PARKER – RUDOLPH SUBDIVISION

The purpose of this application is to create a three-lot subdivision from a metes and bounds parcel.

APPLICATION NUMBER 9 DATE January 5, 2006

PARKER-RUDOLPH SUBDIVISION

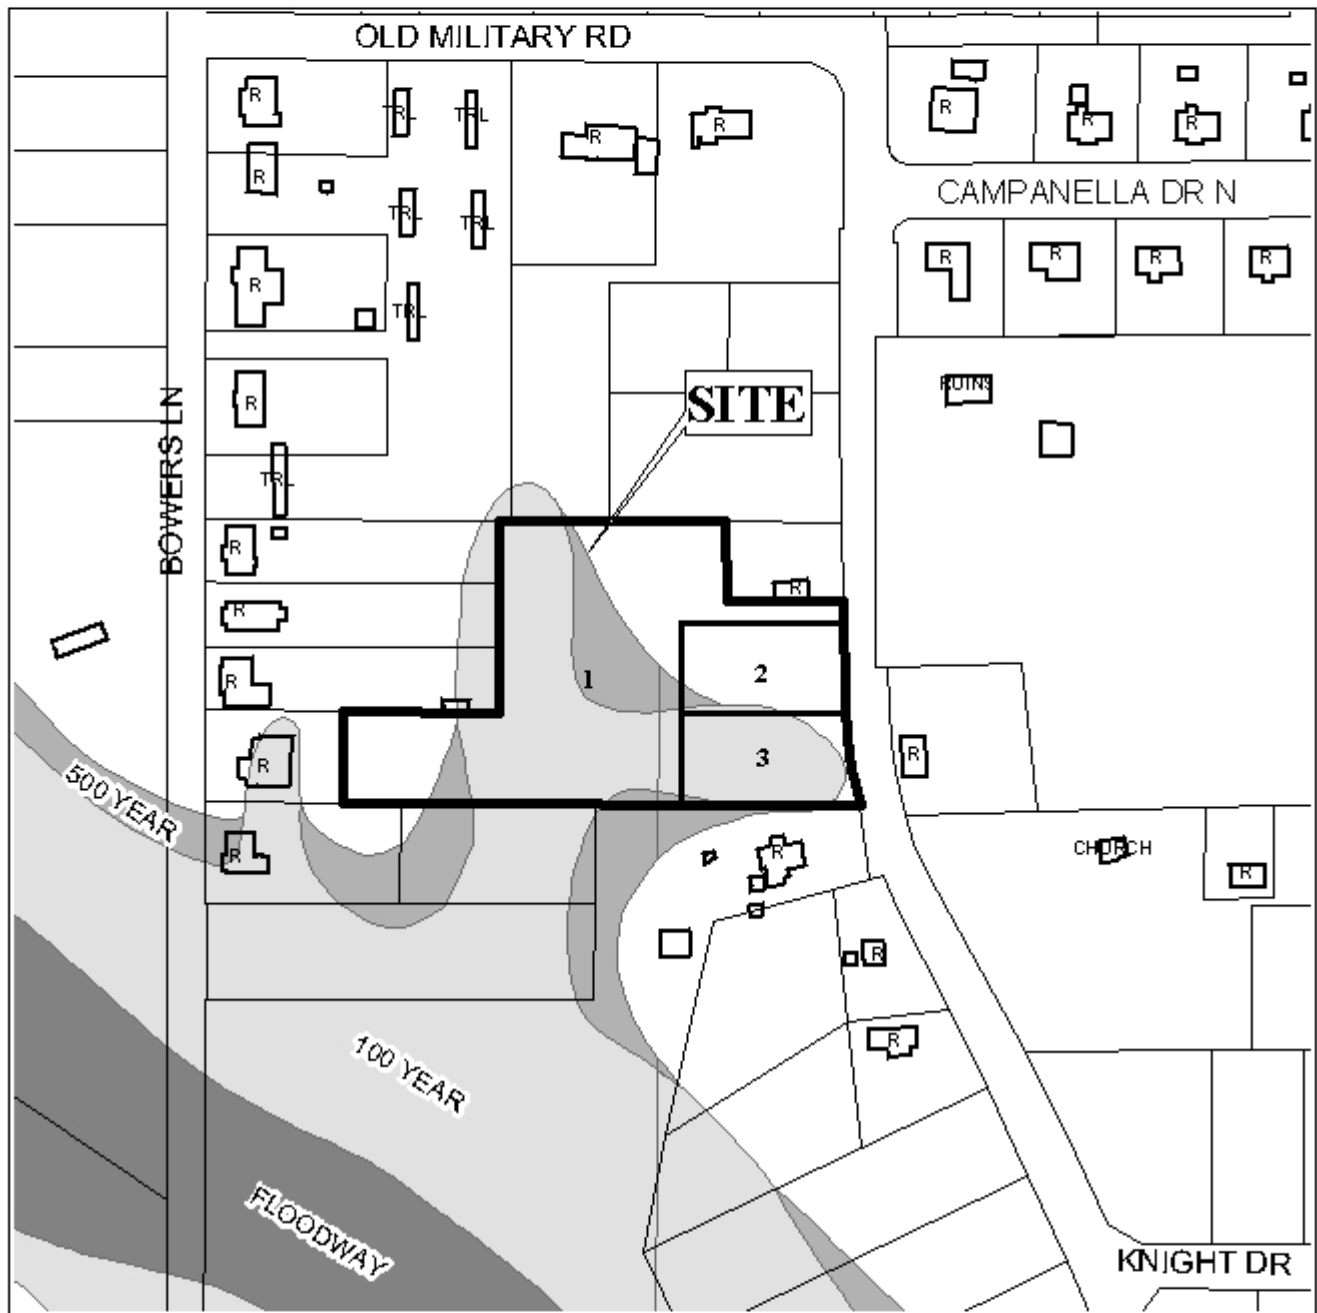
As indicated on the plat, Lot 1 is flag-shaped with 25-feet of frontage. Section V.D.1. of the Subdivision Regulations states “the size, width, depth, shape and orientation of lots and the minimum building setback lines shall be appropriate to the location of the subdivision and the type of development and use contemplated”. Therefore, a waiver of Section V.D.1. of the Subdivision Regulations would be required. Additionally, any further resubdivision of Lot 1 would not meet minimum requirements of the Subdivision Regulations.

The 25-foot minimum building setback lines are not shown, but would be required on the final plat.

With a waiver of Section V.D.1., the plat will meet the minimum requirements of the Subdivision Regulations and is recommended for Tentative Approval subject to the following conditions: 1) the placement of a note on the final plat stating that no further resubdivision of Lot 1 unless additional frontage is provided; 2) the approval of all applicable federal, state and local agencies prior to the issuance of any permits; 3) the placement of a note on the final plat stating that any property that is developed commercially and adjoins residentially developed property shall provide a buffer, in compliance with Section V.A.7. of the Subdivision Regulations; and 4) the placement of the 25-foot minimum setback lines on the final plat.
